Re: Response to Request for Further Information – Section 92 RMA

Application: BUN60453420 (LUC60453421 and DIS60453422)

We write in response to Council's Section 92 Request for Further Information (dated 13 August 2025) for the above application. The following responses address items 2, 5, 6, 7, 8, 11, and 16–20 of the request.

DWG LONGITUDINAL SECTION - DRIVEWAY
CH. 0.000 - 160.000

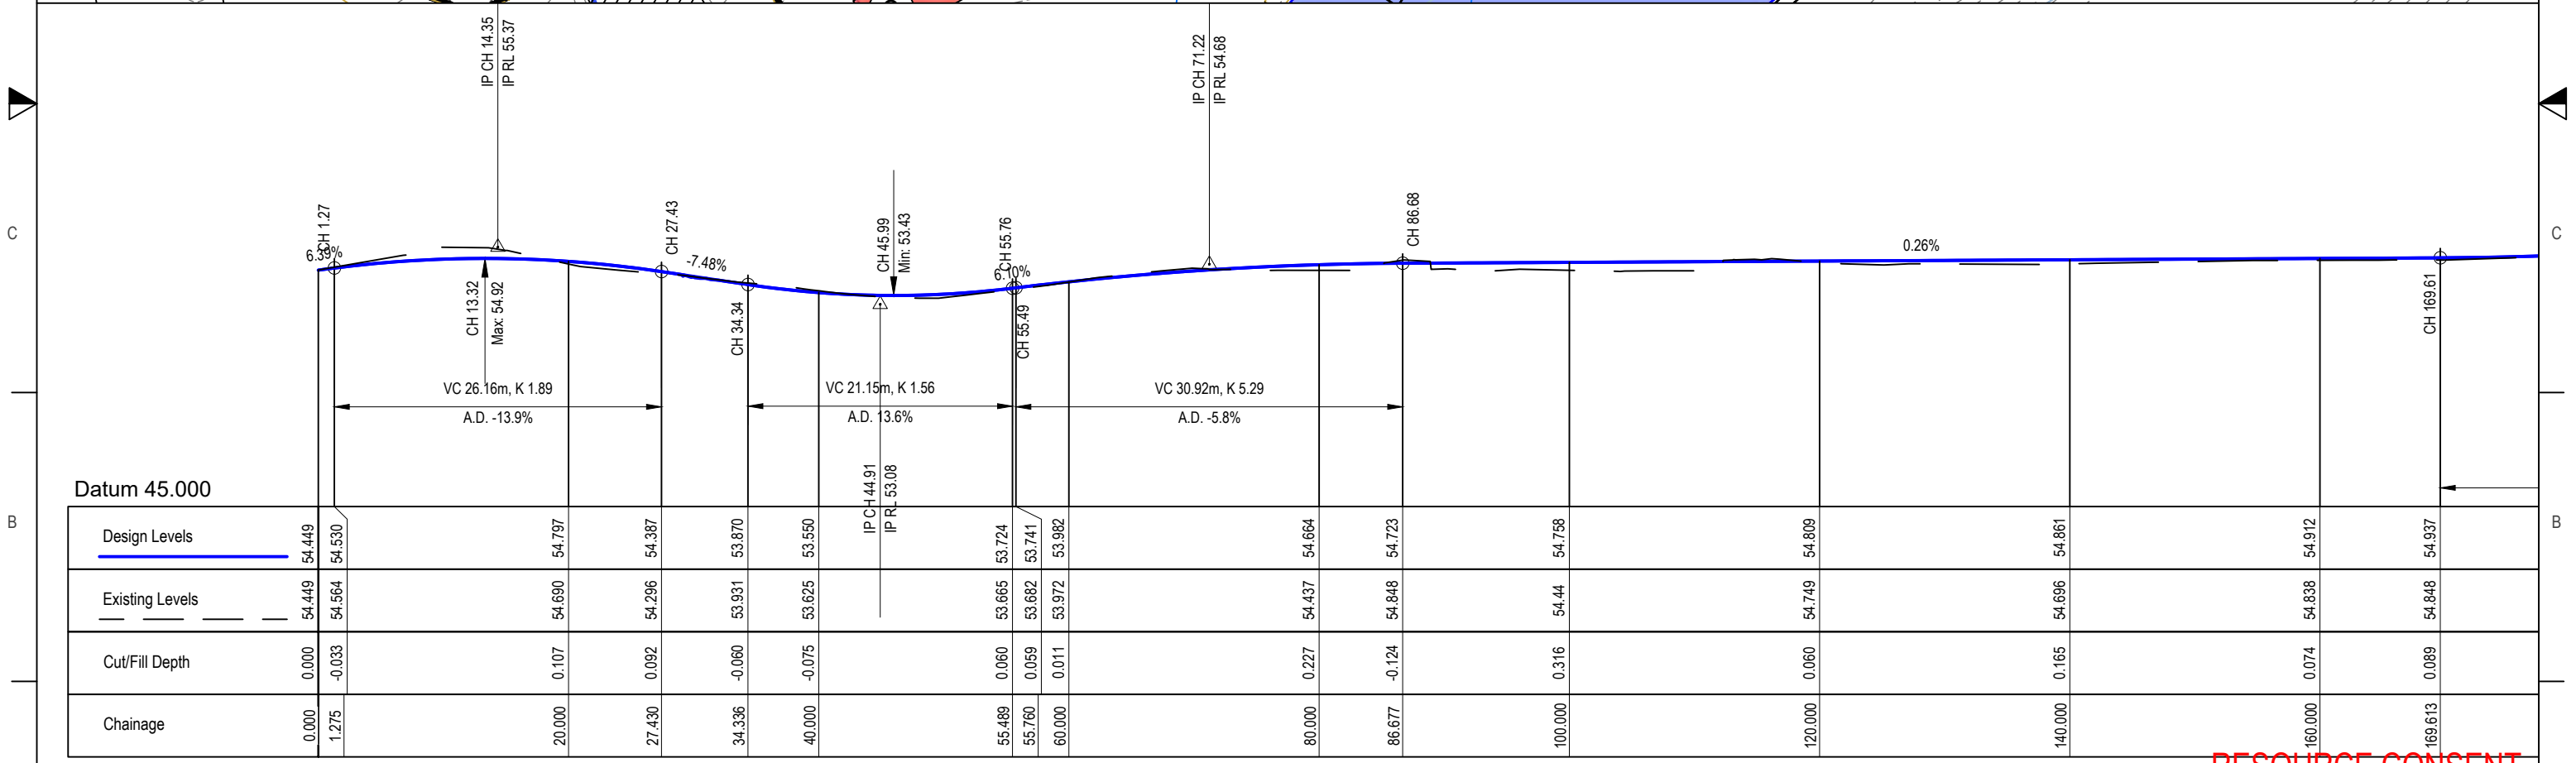
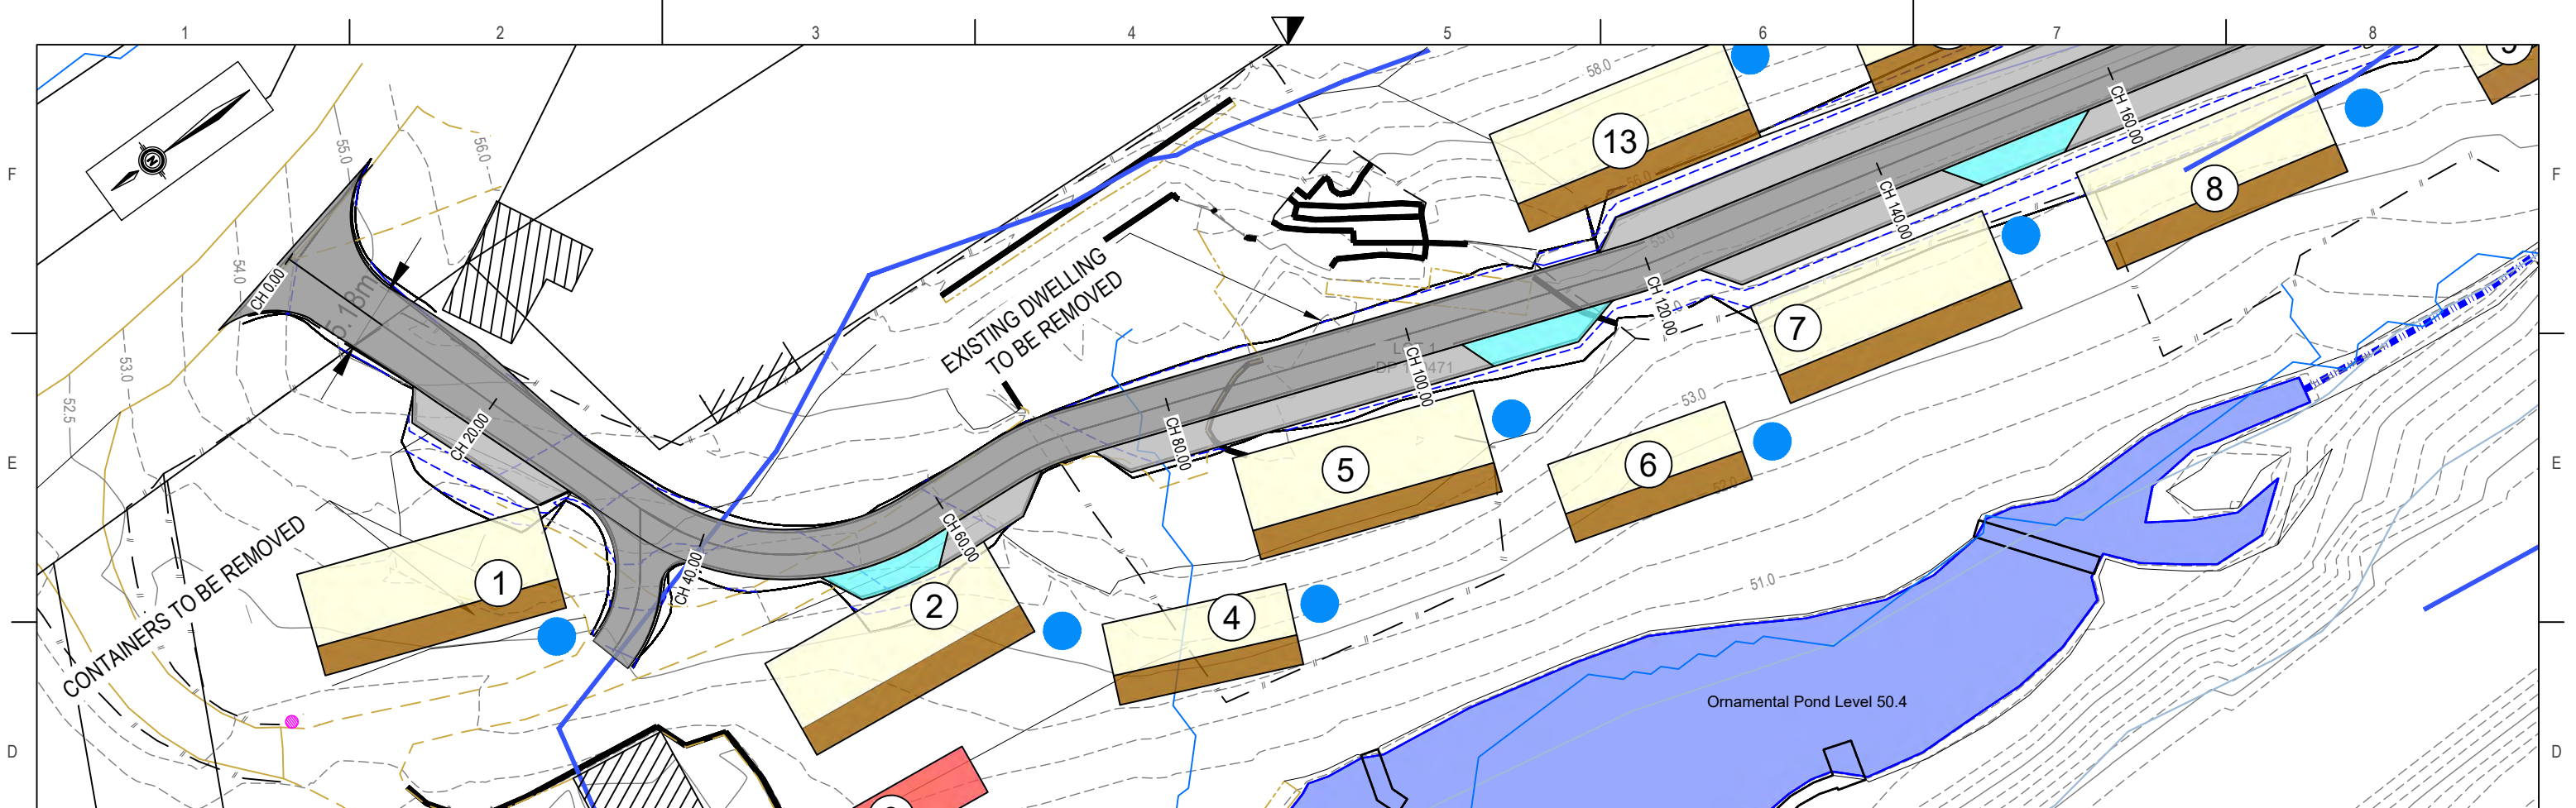
Q11. The Council’s traffic engineer considers that parking on gradients greater than 5.0% is not appropriate ... Please either provide additional assessment ... or make the necessary amendments.

The parking layout and vertical geometry has been reviewed and emended. The two spaces with cross gradients exceeding 7.5% have been adjusted through minor regrading of the section CH20-CH30. Updated gradient is shown on Long Section LS-01 Rev C.

DWG WASTEWATER AND STORMWATER PLAN

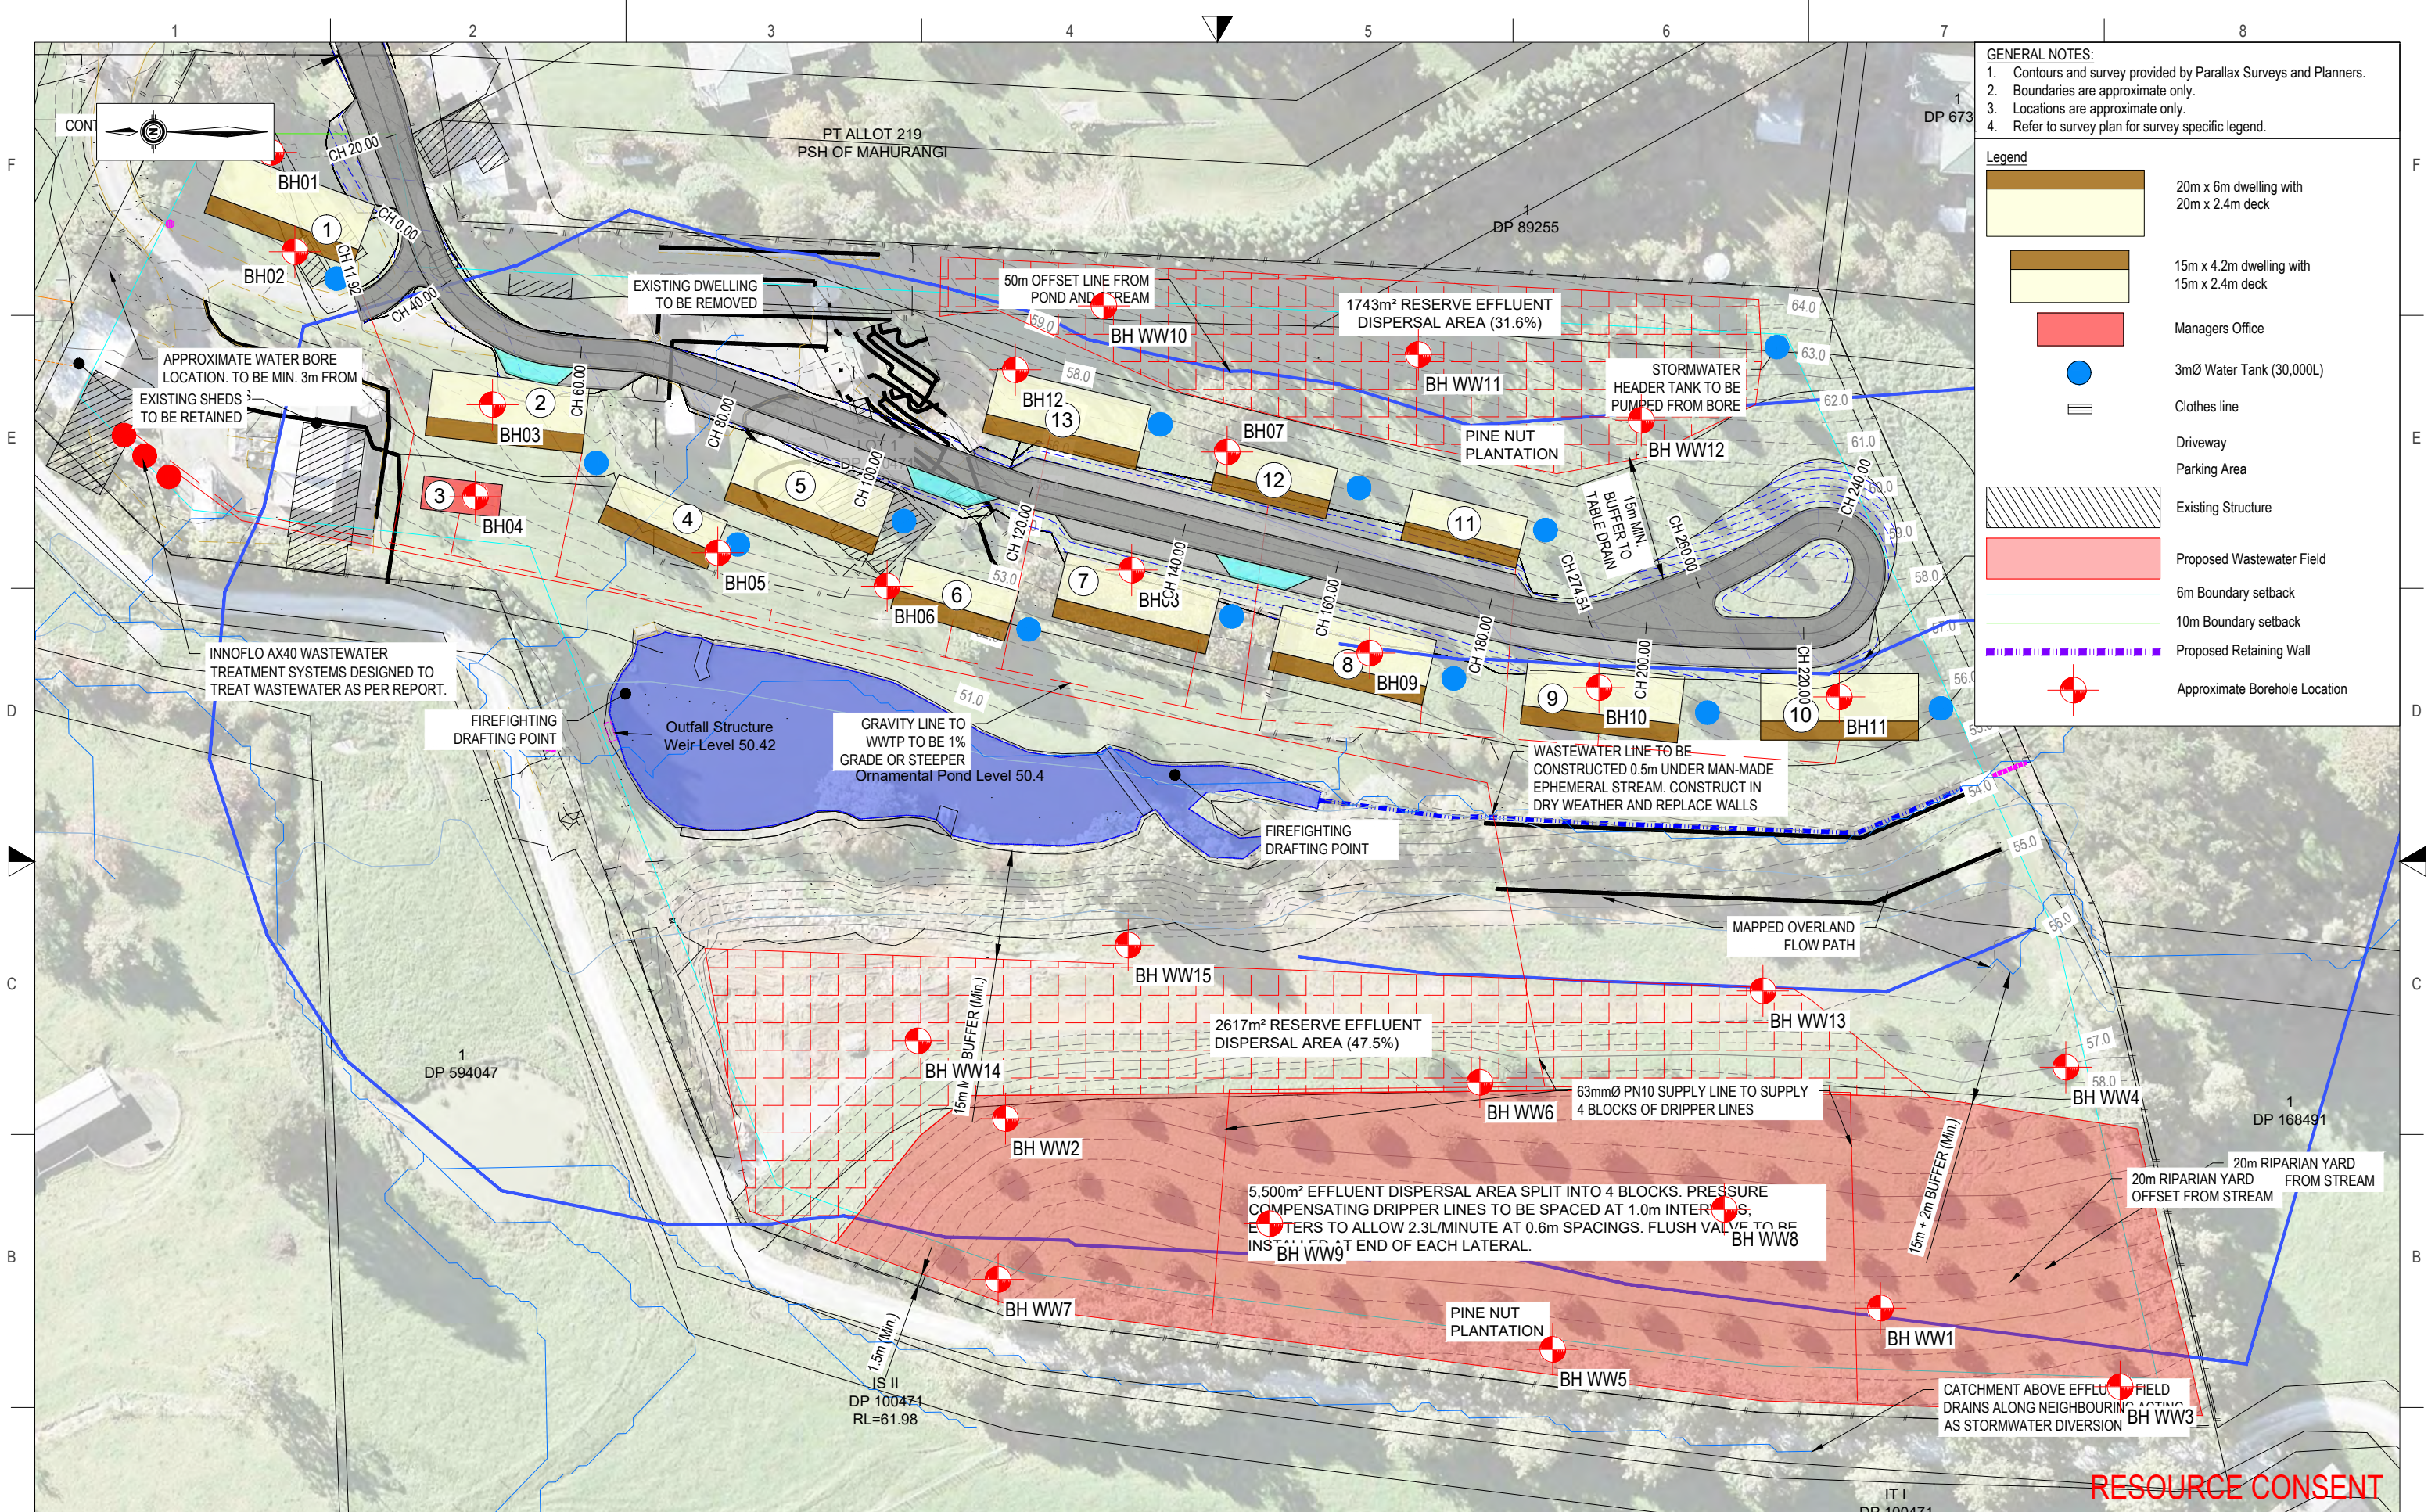
Q19. It has not been demonstrated that the reserve field is at least 15m away from surface water features, such as overland flow paths and the pond. If the field is to be closer than 15m, a tertiary system installed could be used, which would reduce the distance required to 10m. Please address this

The reserve disposal field has been reconfigured to achieve a minimum 15 m setback from surface water features. This is shown on the updated **Wastewater and Stormwater Plan W-01 Rev C**. The Reserve area has been reduced to 80% of the primary field area.
